ITEM: 6.8	REPORT SUMMARY MINOR VARIANCE APPLICATION FILE NUMBER A188/23
------------------	--

**MINOR VARIANCE APPLICATION
FILE NUMBER A188/23
10 BRADWICK DRIVE, CONCORD**

CITY WARD #:	4
APPLICANT:	10 Bradwick Drive Ltd.
AGENT:	Intel Power Inc.
PROPERTY:	10 Bradwick Drive, Concord
ZONING DESIGNATION:	See below.
VAUGHAN OFFICIAL PLAN (2010) DESIGNATION:	Vaughan Official Plan 2010 ('VOP 2010'): "General Employment".
RELATED DEVELOPMENT APPLICATIONS:	None
PURPOSE OF APPLICATION:	Relief from the Zoning By-law is being requested to permit proposed storage (tent structure and shipping containers).

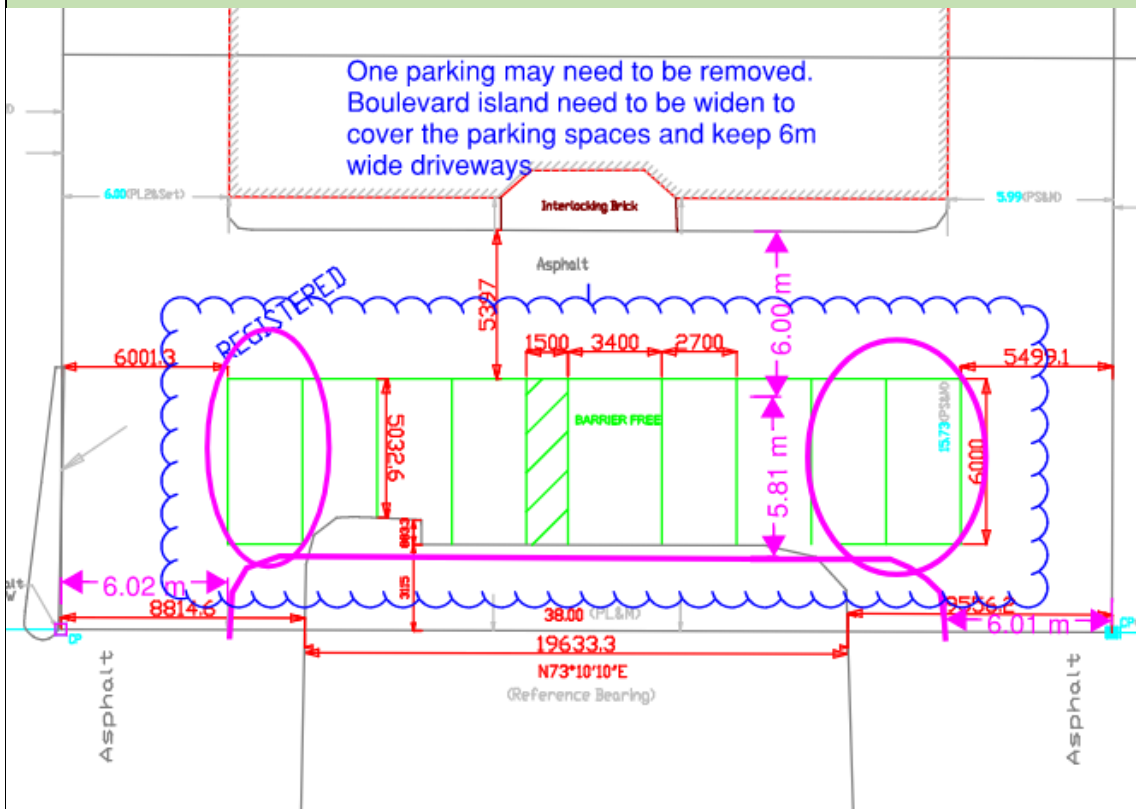
For Variances #3 and #4, there are no objections to the parking space dimensions (2.7m x 5.7m for 90-degree parking) and parking supply of 16 spaces as the parking supply would fulfill the Zoning By-law 001-2021 requirements:

However, staff has safety concerns with few parking space locations along the south frontage that circled in pink/magenta in the capture below.

The circled three parking spaces are within the existing driveways (over 8.5m wide) interfering active travel paths. The boulevard island between the driveways should be widened and modified for the proposed parking spaces along the south frontage, see staff's sketch above for suggested changes.

Parking space dimension and two-way driveway width should comply by-law 001-2021 requirements. As such, one of the parking spaces along the south frontage must be removed.

A 6m aisle should be provided for 60-degree to 90-degree parking spaces. If there are constraints to provide a 6 m aisle, the driveway aisle between the parking spaces and the building frontage should be changed to one-way travel with proper signage (e.g. one-way sign, do not enter sign, stop sign, etc.) and the parking spaces should be revised to 45-degree angle parking (2.7m x 6.0m).

For Variance #5, staff cannot support the proposed aisle width reduction. A minimum 6m aisle is required for two-way travel. Please see above comments for suggestions to comply Zoning By-law 001-2021.

For Variance #6, truck maneuvering diagram is required for further review.

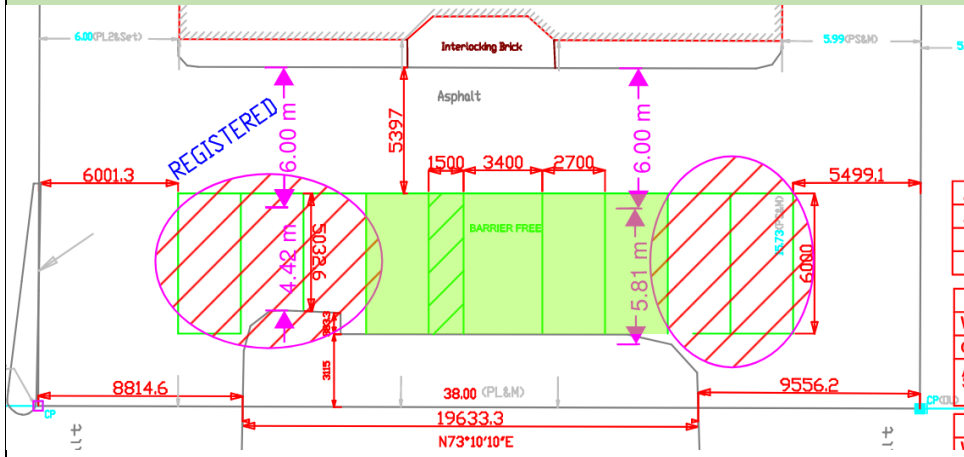
There are no painted parking lines on this property (picture attached), I just drew them in on the drawing based on dimensions I was given from the bylaws to prepare the parking calculations.

Having said that, the front parking spaces are messageable, so the length of the parking spaces can be considered to be 5.8m to allow the 6.0m clearance for 2-way traffic so variance #5 would no longer apply. I put in the barrier free parking space even though there was none in the original building plan back in the 80's. The boulevard can not be changed, the bump out is to accommodate the pad mounted transformer (can be seen in the attached picture). If we need only 15 spaces, then I can remove one space from the front and re-distribute the spaces so that variance #6 would no longer apply.

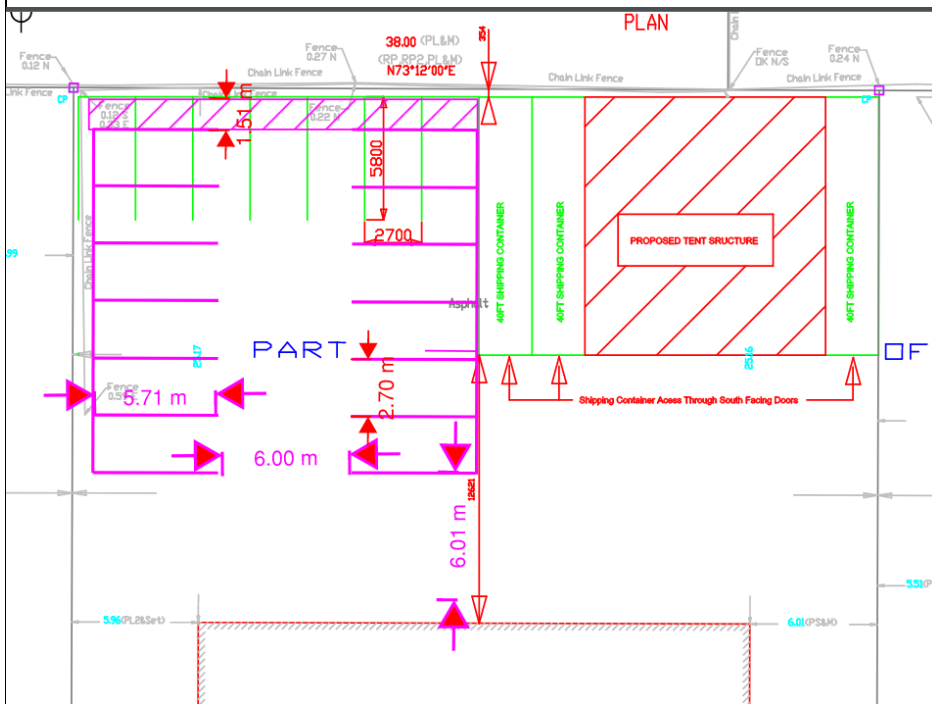
If the boulevard cannot be changed, a total of 5 parking spaces that are encircled must be removed from the south frontage (i.e. 4 parking spaces highlighted in green along the south frontage can remain). The 2 parking spaces in front of the transformer pad must also be removed as they do not meet the minimum length requirements as shown below.

The parking in the rear can be rearranged to accommodate the remaining 11 required parking spaces. Please see sketch below for suggested changes to the parking at the rear of the site in pink/magenta.

This parking configuration is what the city is okay with allowing. Please email an updated drawing to [@Committee of Adjustment](mailto:Committee of Adjustment) so that Development Engineering may conclude our review.

PROJECT 24013

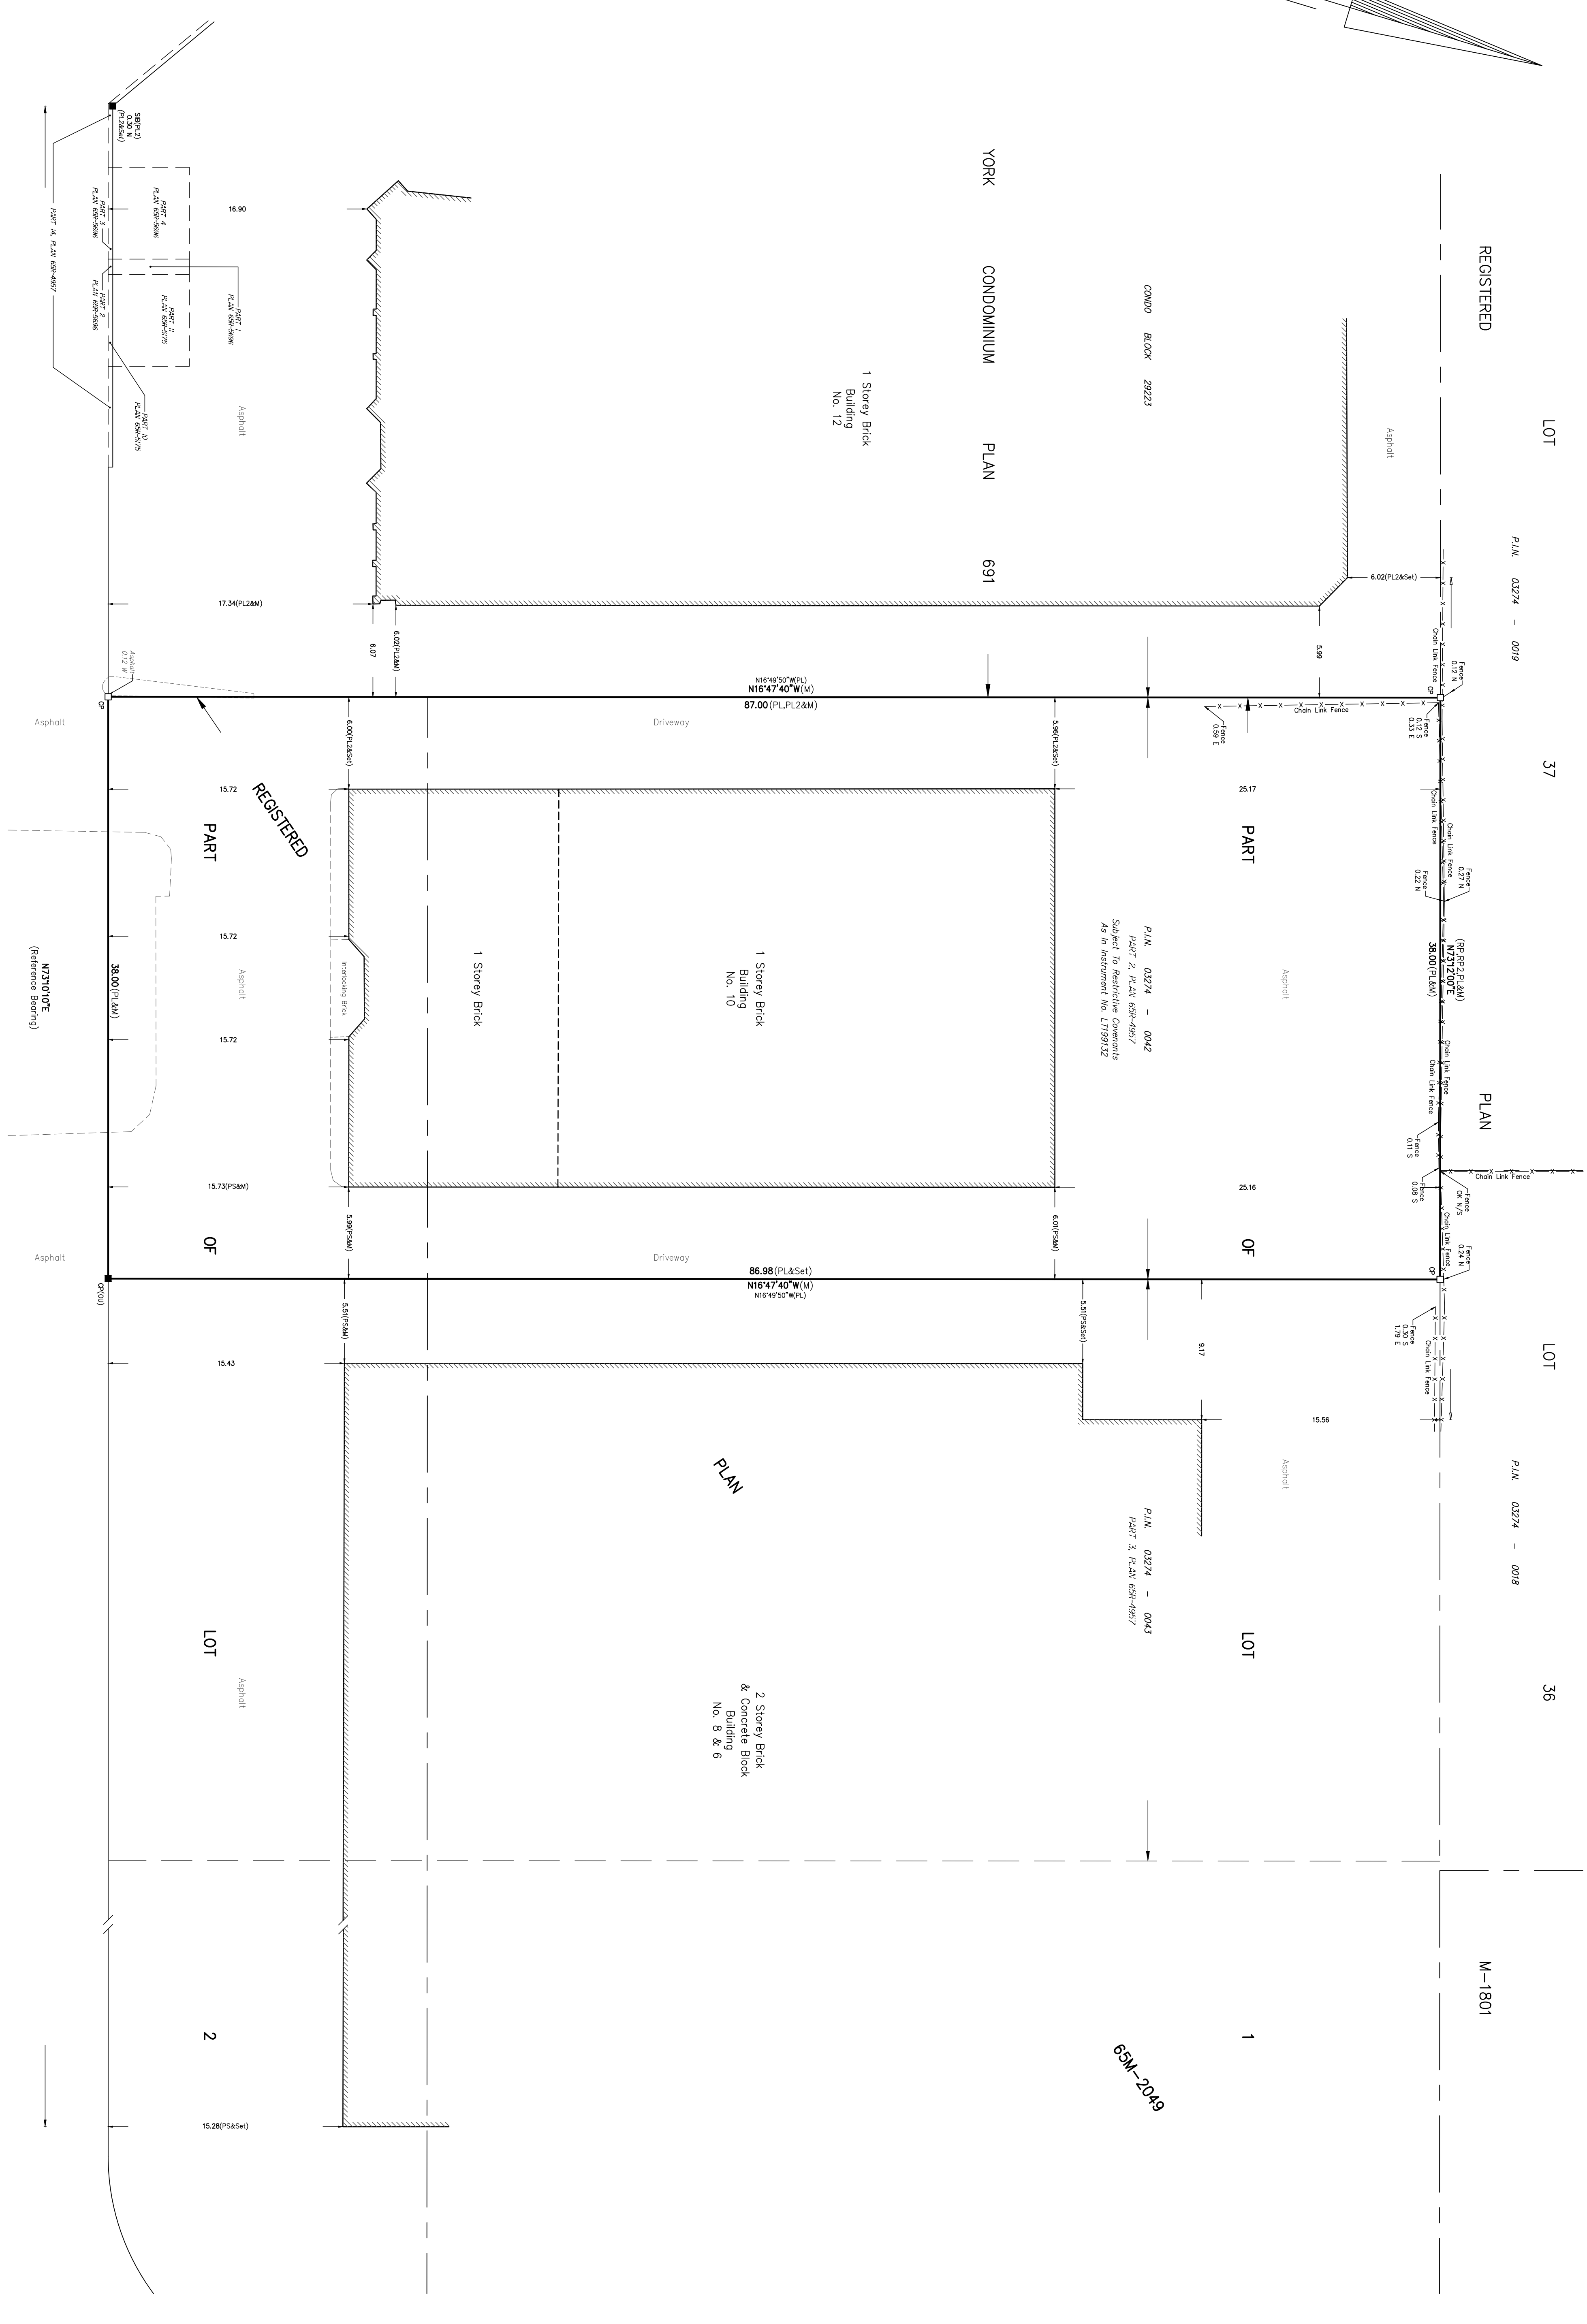
Zoning By-law 001-2021	
1	Additional information is required in regard to the minimum number of parking spaces required in the Zoning By-law. Site statistics shows 16 parking spaces are proposed however, 17 parking spaces are shown on the Site Plan provided. Applicant to please clarify and amend site statistics or Site Plan for review.
